Sicherheitsmitteilung SM 202102(1)

Bezug: 2021-02 SM UPT SE Reserve-Klappe Instruct 065 Rev 0

Vector Student SE Replacement Flap Process

VECTOR 3SE RESERVE PIN COVER FLAP REPLACEMENT

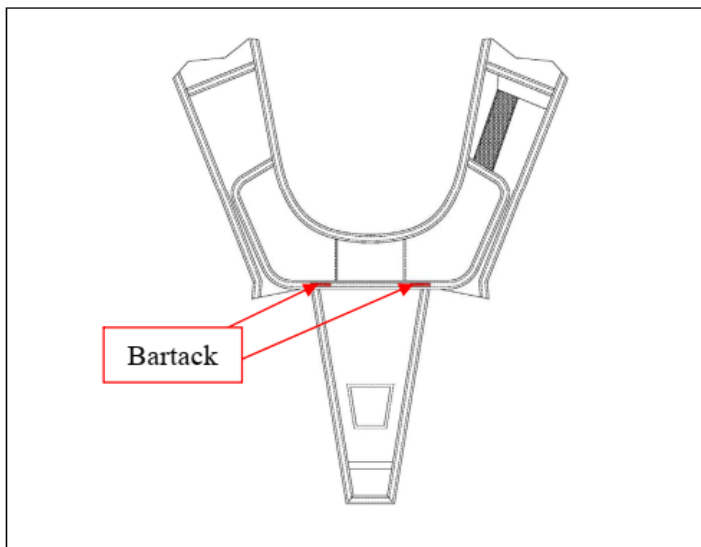
Before removing the Reserve Pin Cover flap that is being replaced, the housing needs to be detached from the clamp that secures it to the housing anchor loop.

This can be done using a screwdriver and an awl (or similar tools) to carefully pry open the clamp until the housing is free to move.

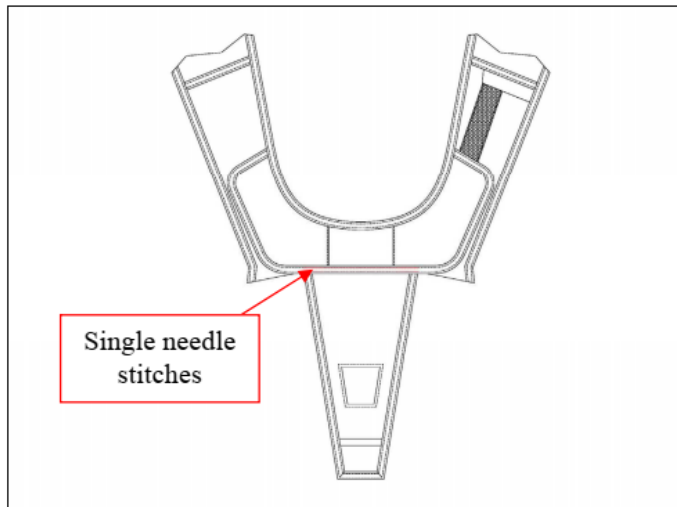
Discard the old clamp and Type-1

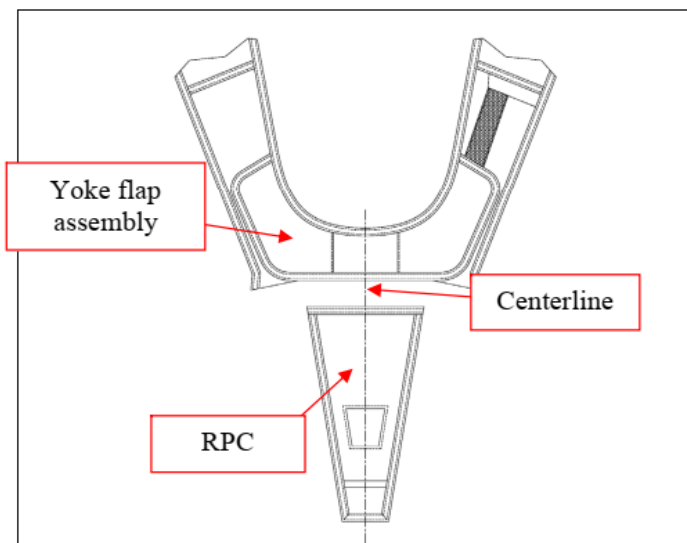
Carefully remove the two (2) indicated bartacks

Next, carefully remove the two rows of single needle stitching attaching the RPC to the Yoke flap assembly.

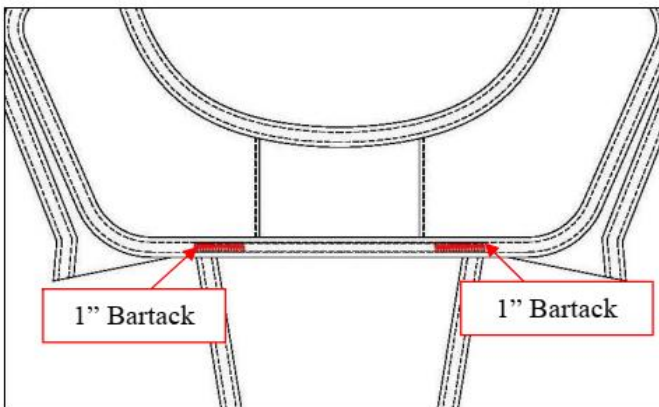
Mark the centerline on both the RPC and the yoke flap assembly before sewing to assist in proper alignment.

Installation of the replacement RPC is the reverse procedure.

Position the RPC so that the top bound edge is aligned with the binding tape of the Yoke flap.

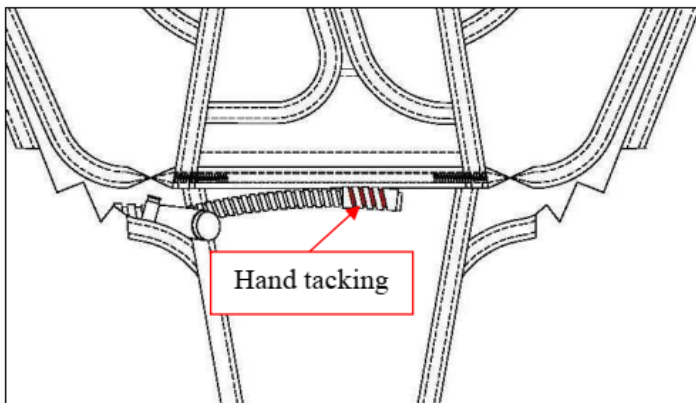
Reinstall the housing with the new clamp and Type-1 webbing.

Place the clamp on the housing first. Then pass the Type-1 webbing through the Housing loop anchor looping it back over to align the cut ends.

Move the clamp along the housing capturing the Type-1 until it is against the housing anchor.

The end of the housing should be even with the edge of the housing anchor.
